New Jersey Offshore Wind Transmission Proposal

New Jersey Board of Public Utilities and PJM

Response to Clarifying Questions Set 1 Boardwalk Power Portfolio

Docket No. QO20100630

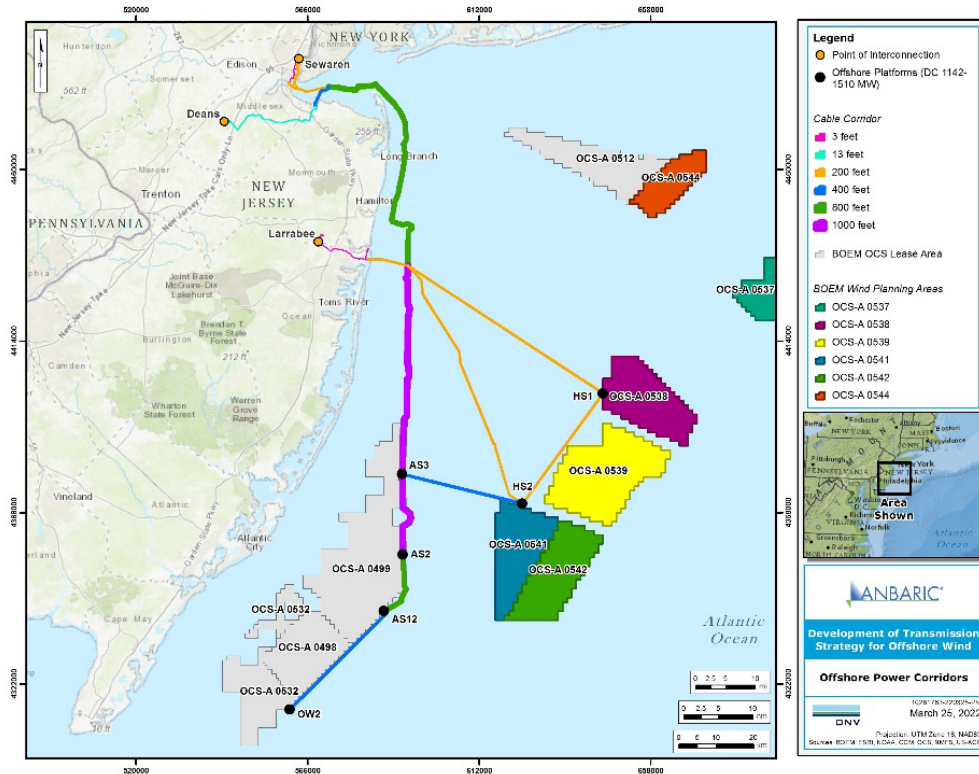
Please describe how your proposed solutions will minimize environmental impacts and permitting requirements through the use of common corridors that can accommodate more than one transmission cable, including an estimate of the miles in which facilities/infrastructure will be co-located within a common corridor and miles in which facilities/infrastructure will be located in separate corridors.

The use of HVDC technology minimizes the environmental impact and permitting requirements due to its significantly higher capacity per cable circuit compared to AC, thus requiring far fewer cables, and a significantly narrower right-of-way. This space saving property enabled all single circuit land transmission routes to be designed to utilize municipal roads as common corridors. Utilizing paved roadways minimizes environmental impacts as they are considered brownfield common corridors. As such, environmental permitting is more easily facilitated as compared with greenfield common corridors.

The submissions where two circuits are required, will be co-located in municipal roadways. To comply with guidelines to avoid NERC Category P7 events (i.e., common structure contingency events modified for underground installations), the circuits will be required to be separated by a minimum distance of 10 feet.

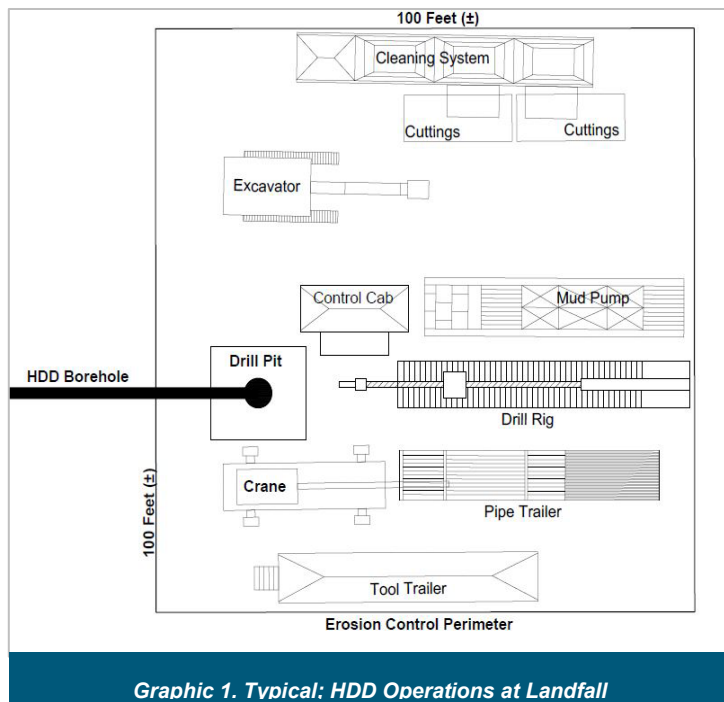
Cable Installation: Please provide more details regarding your proposed cable installation methods through the Arthur Kill and Raritan Bay.

The diameter of the bores and conduits installed by the HDD process at the Landfall will depend upon the type and location of known underground utilities and other subsurface structures/foundations in the vicinity. Initial evaluations indicate that two boreholes approximately 18-24 inches in diameter will be required for the cable’s landfall transition to the underground Transition Vault on shore. After completing an HDD bore, a 10-inch high-density polyethylene (HDPE) (or similar material) conduit will be pulled through the boreholes. In one borehole, a smaller 2-inch conduit for the fiber optic cable will be pulled in together with a 10-inch conduit for the HVDC cable. Center-to-center separation between the HDDs will vary with depth depending on soil characteristics.
